PROJECT NAME: FREEDOM HIGH SCHOOL – NEW BATTING CAGES

APPLICATION NO: 01-123111

ADDENDUM #2

ITEM NO. 2.4. SHEET A103 CONCRETE JOINT LAYOUT

Sheet A103 – Concrete Joint Layout

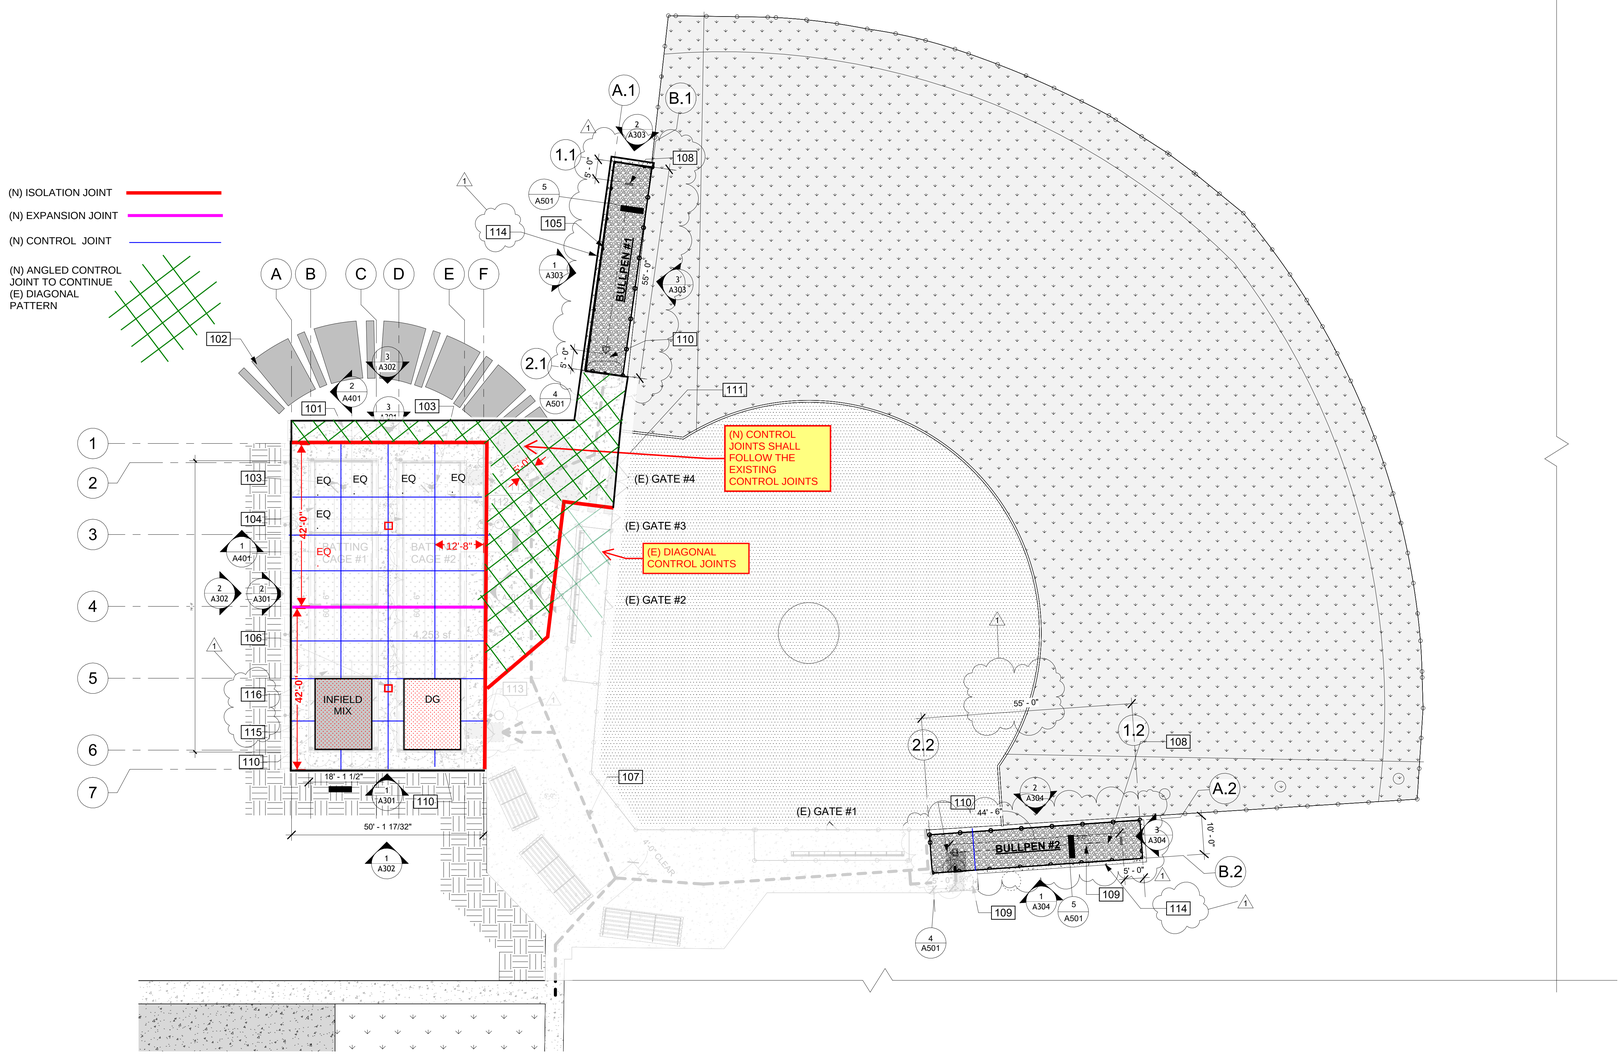
a) Joint layout added to Sheet A103, Proposed Enlarged Plan (Attachment 5). LEGEND: added "(N) ISOLATION JOINT", "(N) EXPANSION JOINT", "(N) CONTROL JOINT" and "(N) ANGLED CONTROL JOINT TO CONTINUE (E) DIAGONAL PATTERN". Notes added: "(N) CONTROL JOINTS SHALL FOLLOW THE EXISTING CONTROL JOINTS" and "(E) DIAGONAL CONTROL JOINTS".

b) Isolation joints (red): at the perimeter of the batting cage concrete slab and around each batting cage pole ground sleeve, drain inlet and fence post pier. Provide premolded joint filler for the full depth of the slab with sealant at the top. No dowels or reinforcing shall pass through an isolation joint.

c) Expansion joint (pink): one expansion joint across the full width of the batting cage slab at approximately mid-length, per Detail 7B/A501 (premolded filler with 1/2" diameter x 18" smooth dowels at 24" on center).

d) Control joints (blue): per Detail 7A/A501. Spacing as shown on Sheet A103, 12'-0" maximum in either direction.
e) Existing diagonal pattern (green): where new concrete flatwork outside the batting cage slab adjoins existing concrete flatwork, new control joints shall continue the existing diagonal control joint pattern. Contractor shall field verify the angle and spacing of the existing joints. New joints shall align with existing joints where new concrete meets existing. The diagonal pattern ends at the isolation joint at the batting cage slab; control joints within the batting cage slab run north-south and east-west as shown.

f) Bullpens #1 and #2: concrete slabs were deleted by Addendum #1, Item 1.2 and replaced with decomposed granite; no concrete slab joint layout applies. Concrete mow strip (Key Note 114): control joints at 10'-0" maximum on center.

A: The joint layout is shown on Sheet A103 (Attachment 5) and described in Item No. 2.4 of this Addendum.

Overhead Batting Tunnel Foundation Details (Sleeve w/ Cold Joint)

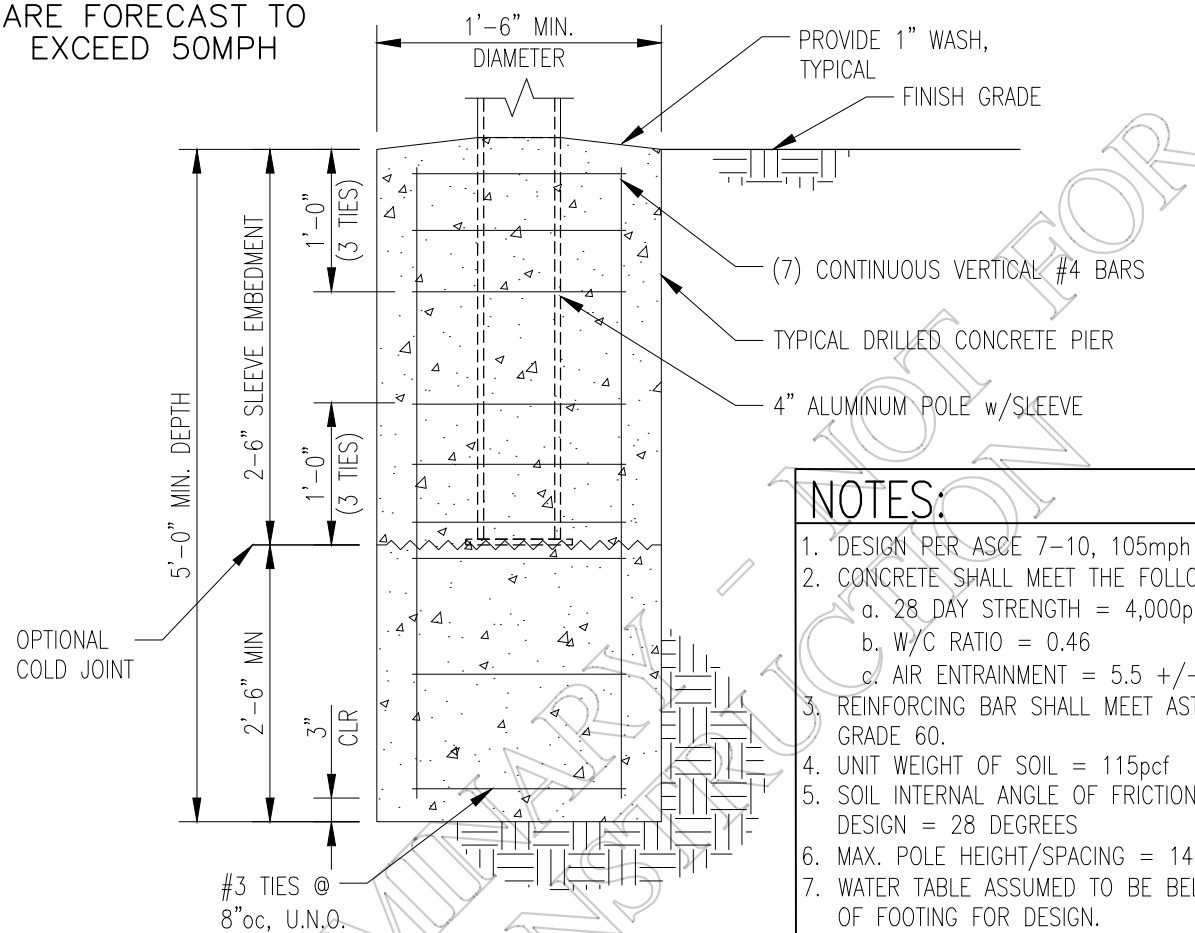
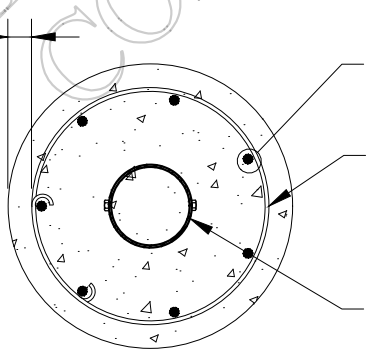
a) Ground sleeves for the batting cage poles (Key Note 100) shall be set in concrete drilled piers at each pole location shown dashed on Sheets A301 and A401.

b) Sheet A501, Drilled Pier Schedule: added item "BATTING CAGE POLE" with height above grade "H" = 14'-8 3/4" (top of cage), pier diameter "D" = 1'-6" and pier length "L" = 7'-0". Pier reinforcing and clearances per Fence Post Footing Detail 6/A501.

c) Ground sleeve size, type and embedment per pole manufacturer. Top of sleeve flush with top of slab (Key Note 102). Slab shall be isolated from the sleeve and pier (see Item No. 2.4) so that the slab does not bear on or restrain the pier. The pole manufacturer's standard foundation detail SK-01 (Sportsfield Specialties, Attachment 6) is provided for reference only for sleeve installation. Pier size and reinforcing shall be as indicated on Sheet A501 and in this Addendum; in case of conflict, Sheet A501 and this Addendum govern.

A: Footings are required. Ground sleeves shall be set in concrete drilled piers. Pier size and detail are provided in Item No. 2.5 of this Addendum (Drilled Pier Schedule and Fence Post Footing Detail 6, Sheet A501).
